Planning Commission Meeting Agenda
Planning Commission Meeting
Thursday, August 13, 2026
7:00 PM

Hartland Township Planning Commission Meeting Agenda Memorandum

Subject: Site Plan with Special Land Use Application #26-007 (Kroger Automobile Fueling and Convenience Station)

Re: Kroger Gas Station – Site Plan Review
SDA Review No. HL25-101

FUEL CENTER
EXTERIOR COLOR ELEVATIONS

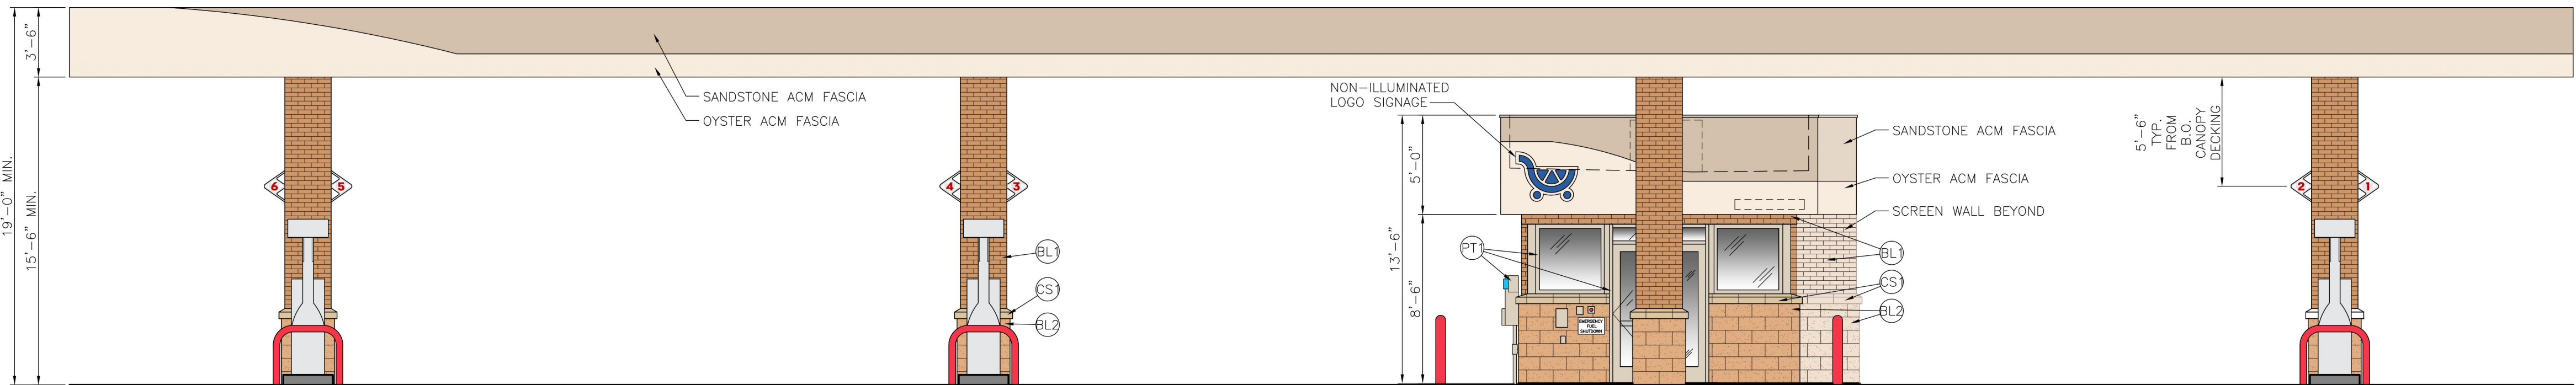
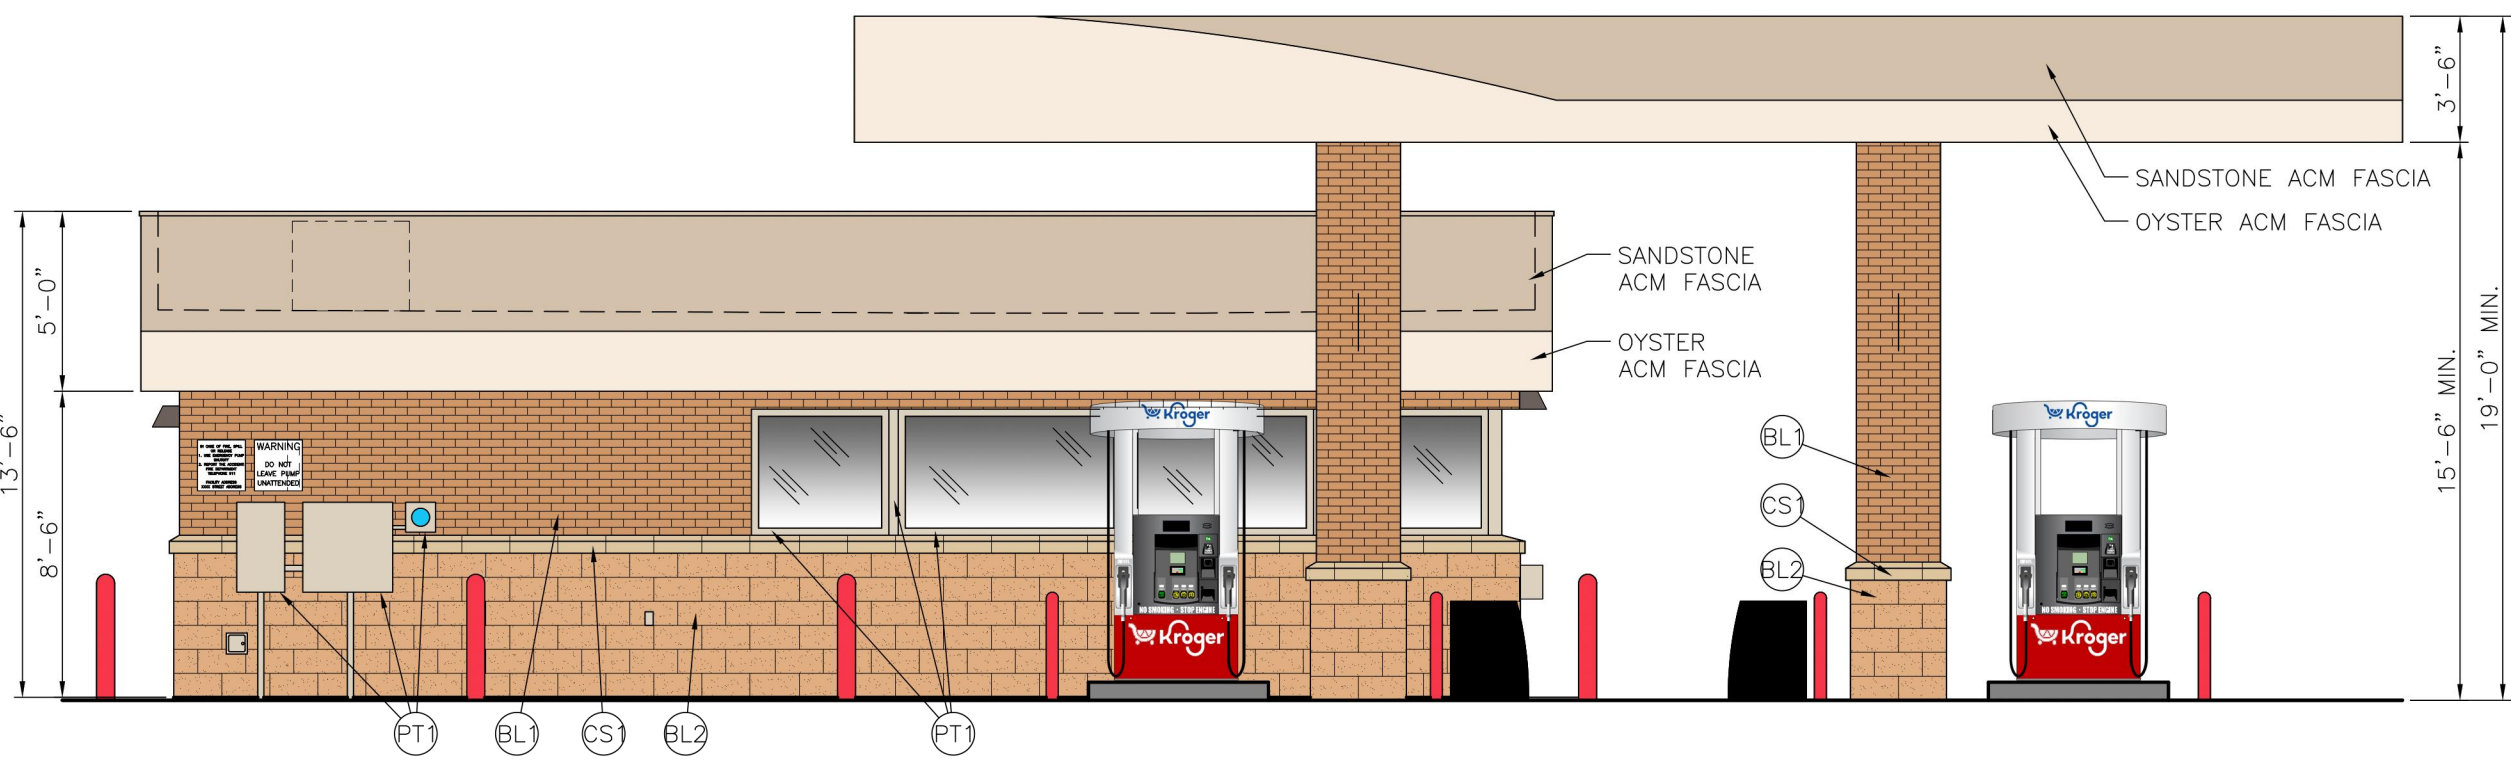
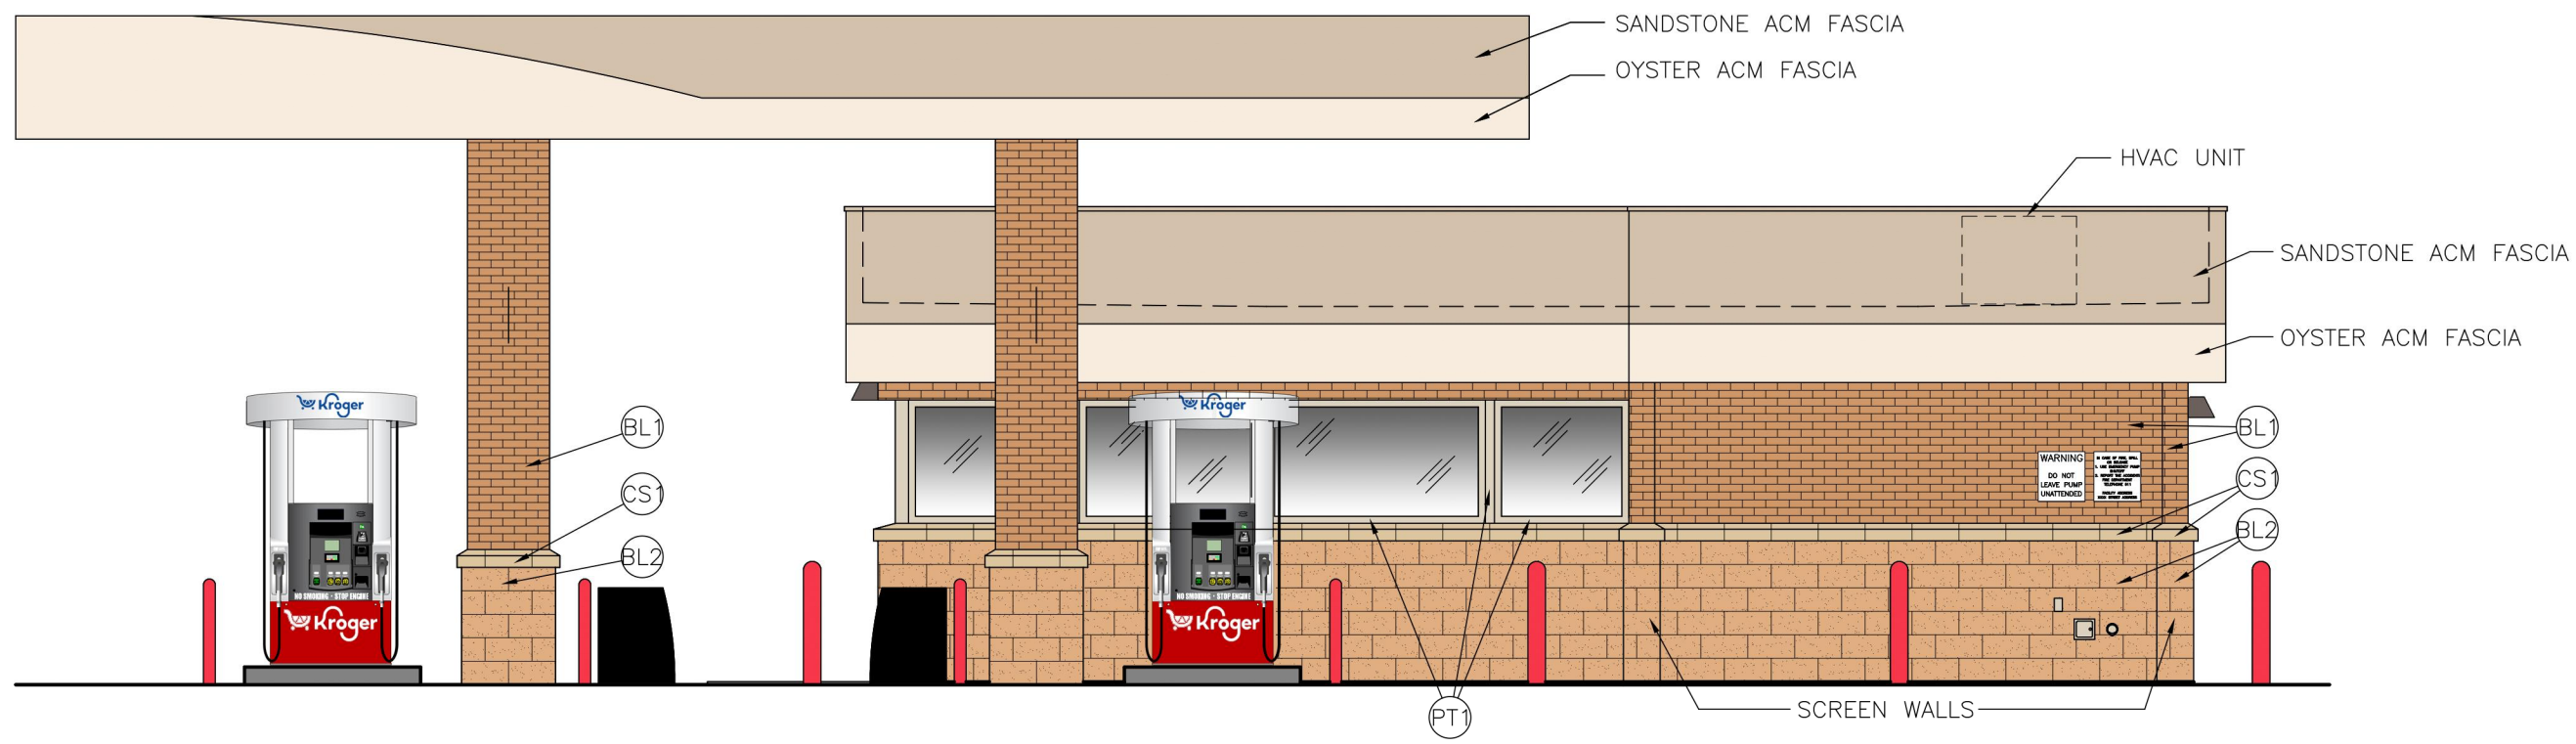
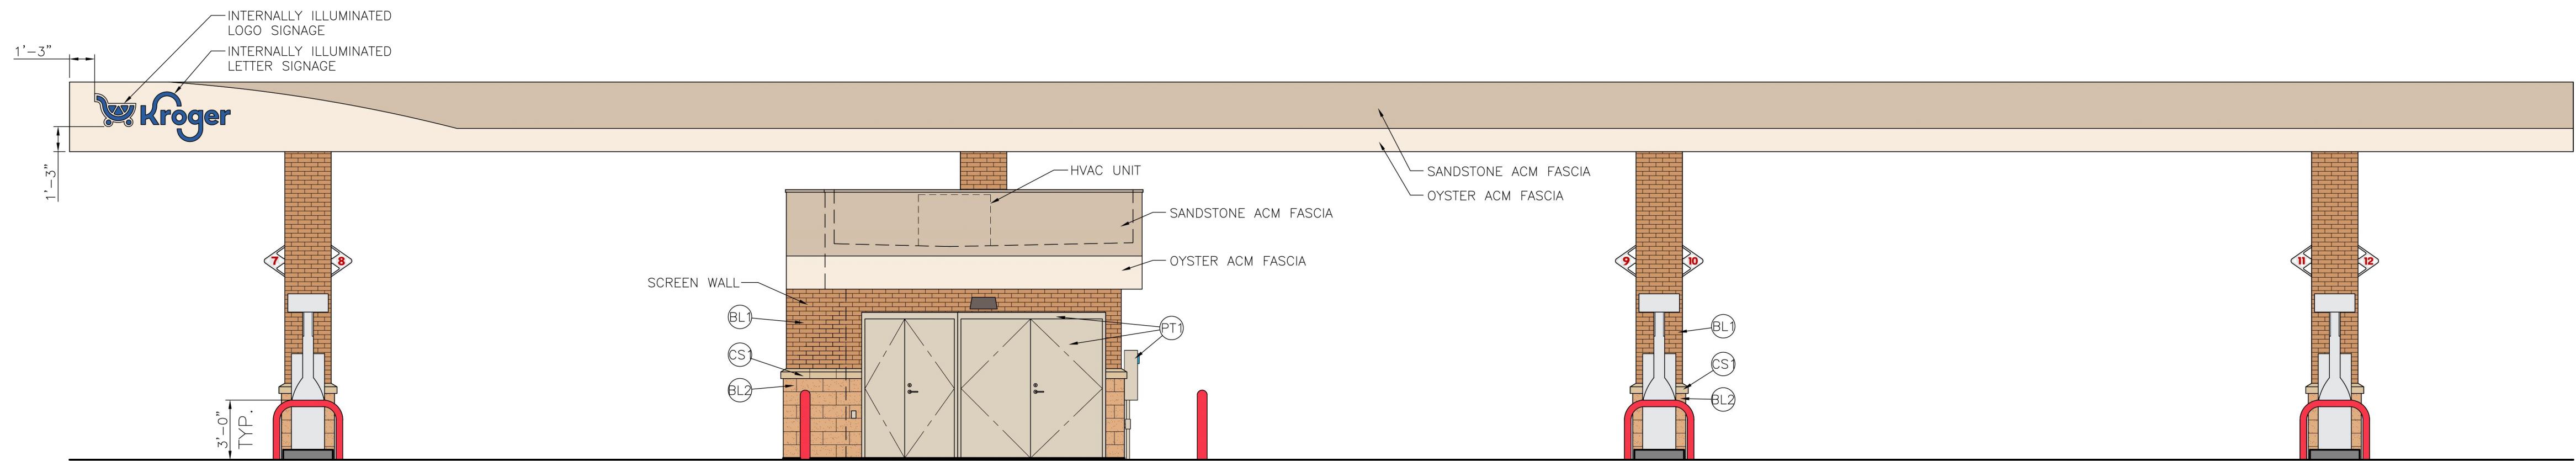
Elevation	Clay Brick (30% min.) Smooth Face Brick Veneer prop.	Decorative concrete masonry unit (Split-faced block 25% max.) CMU veneer on plan	Glass (50% max.)	Aluminum Composite Material (ACM) (20% max.)* Stated % is combined total of 2 colors of ACM	Precast sill (25% max.) (Used “Precast Other” in Ord.)
North	10%	23%	22%	43%	2%
East	14%	30%	12%	40%	4%
West	15%	30%	11%	40%	4%
South	23%	13%	0%	62%	2%

- Meets Requirement? – TBD
- Comment – The Planning Commission to determine if the proposed façade material percentages are acceptable as listed.

- The façade materials listed on this sheet for the two (2) kiosk wing walls/screen walls shall match the façade materials stated on Sheet A0.0 (Exterior Color Elevations).
- The note “Screen walls to shield outdoor equipment” on the west side of the building, shall be removed and replaced with a note that states “Outdoor Storage Area” (for the area between the two (2) screen walls).

A1.1

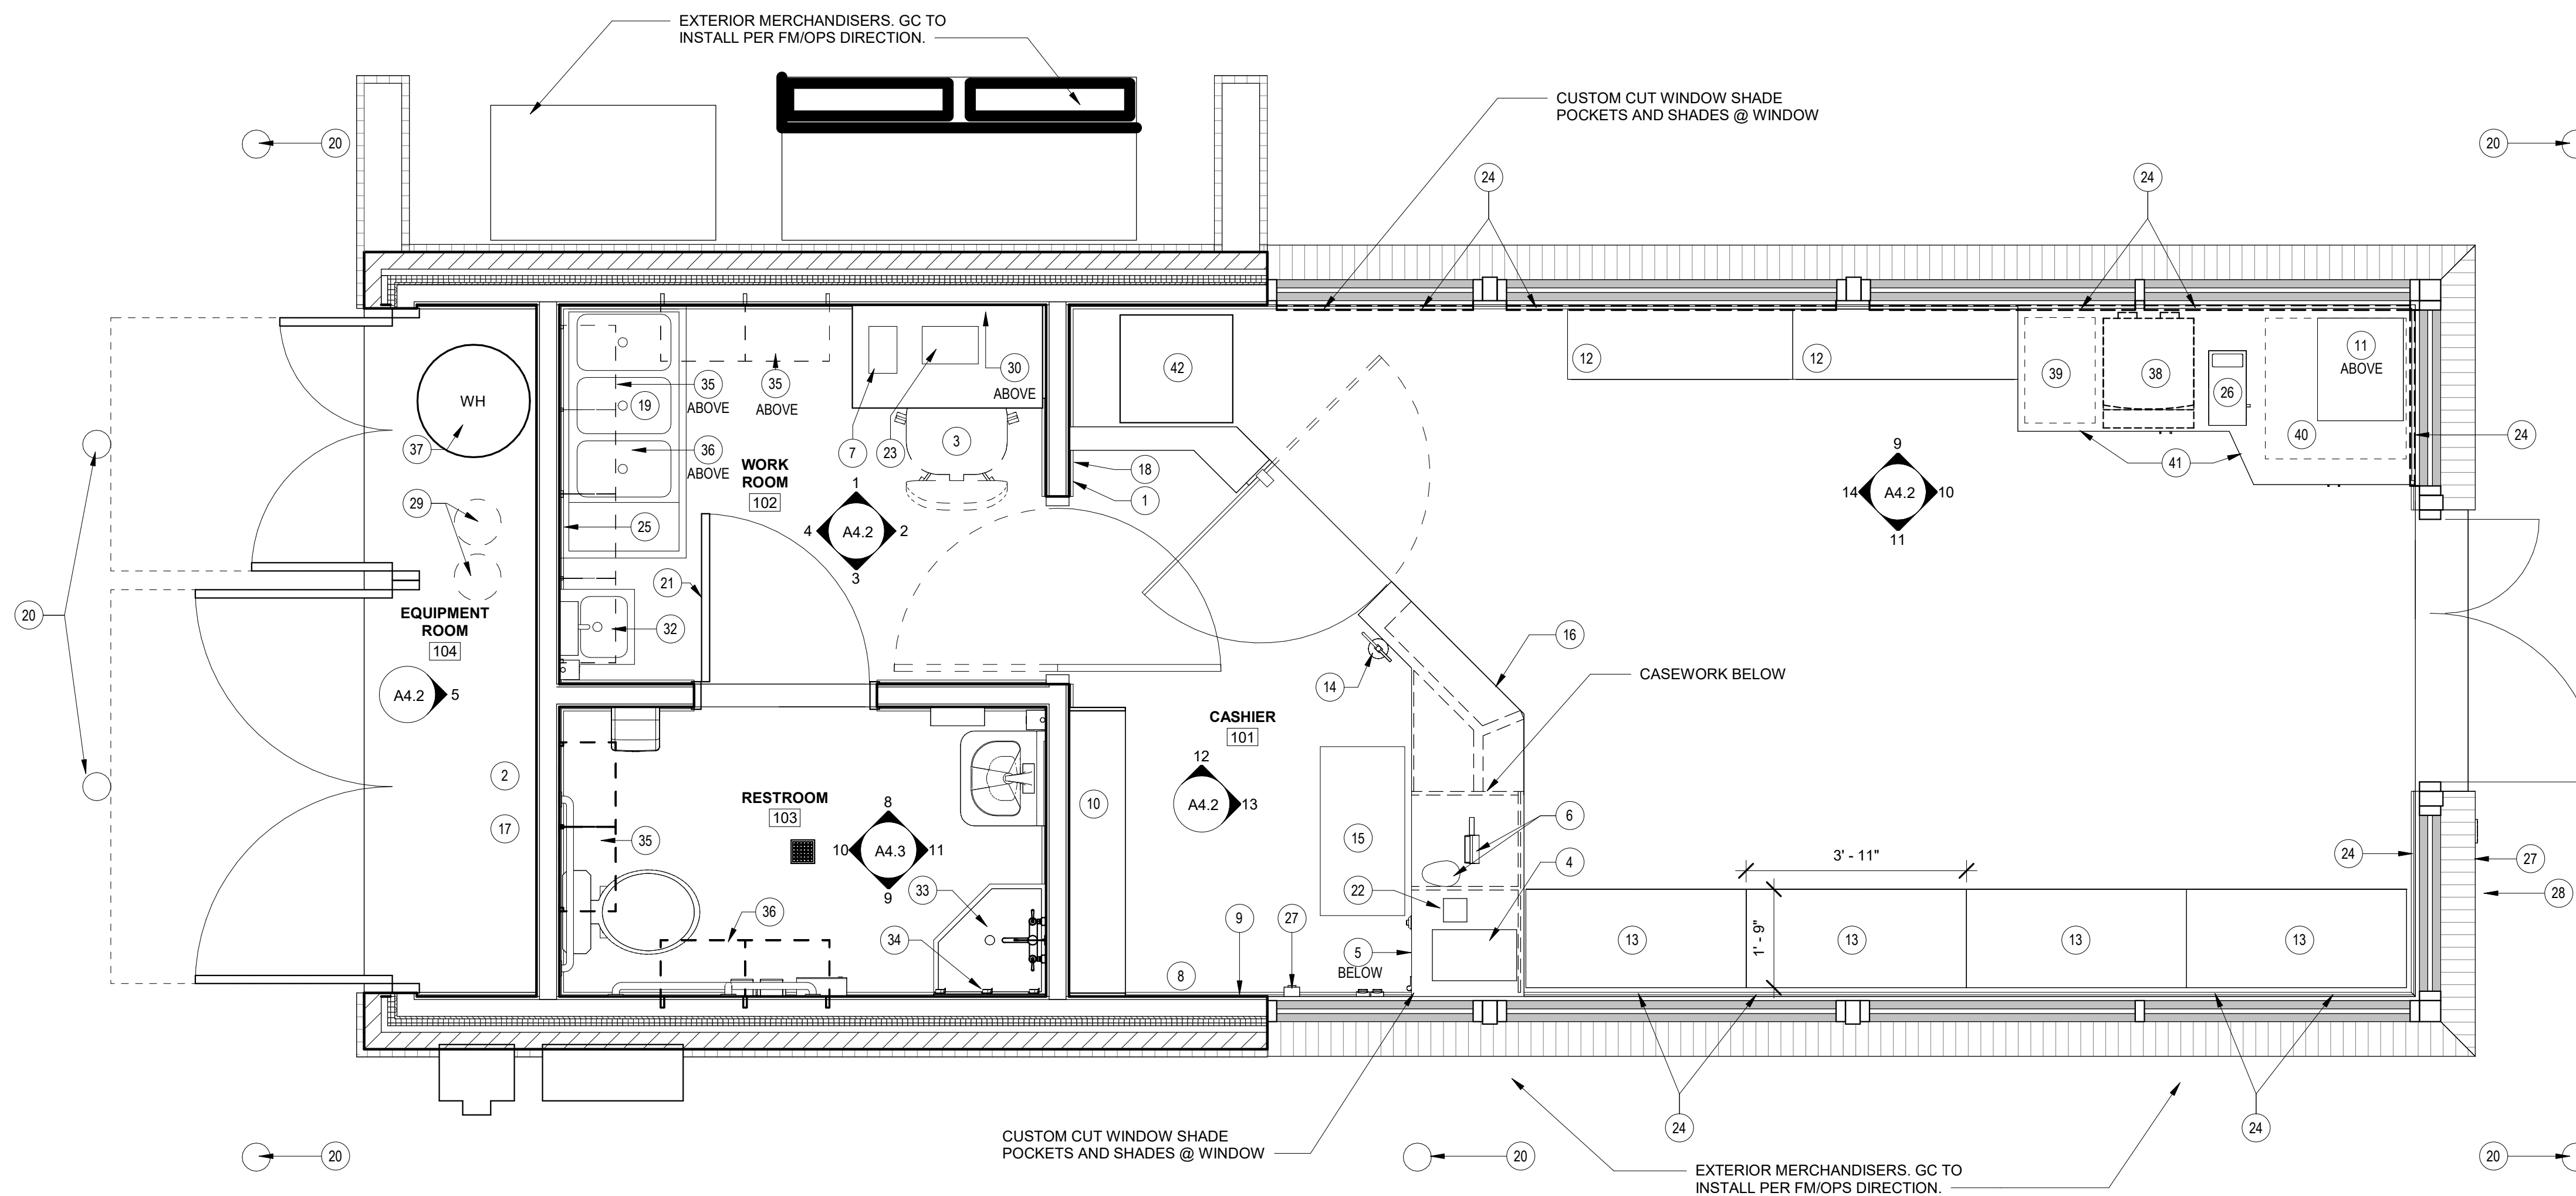
Per Sheet C1.20 an ice merchandiser and spill cabinet are shown in the outdoor storage area. Sheet A1.1 (Floor plan of the building), a note states exterior merchandisers are to be installed in the storage area, however the specifics on the types of products are not provided. The outdoor storage area should be labeled as such and be consistent on all sheets. Specific merchandiser units, cabinets with items for sale, or other items should not be specified on the plans. The understanding is that one (1) outdoor storage area is permitted on the west side of the building, between the two (2) screen walls, as shown on the plans. Specific merchandise/products within the outdoor storage area do not need to be identified on the plans. All products must be placed within the designated outdoor storage area.
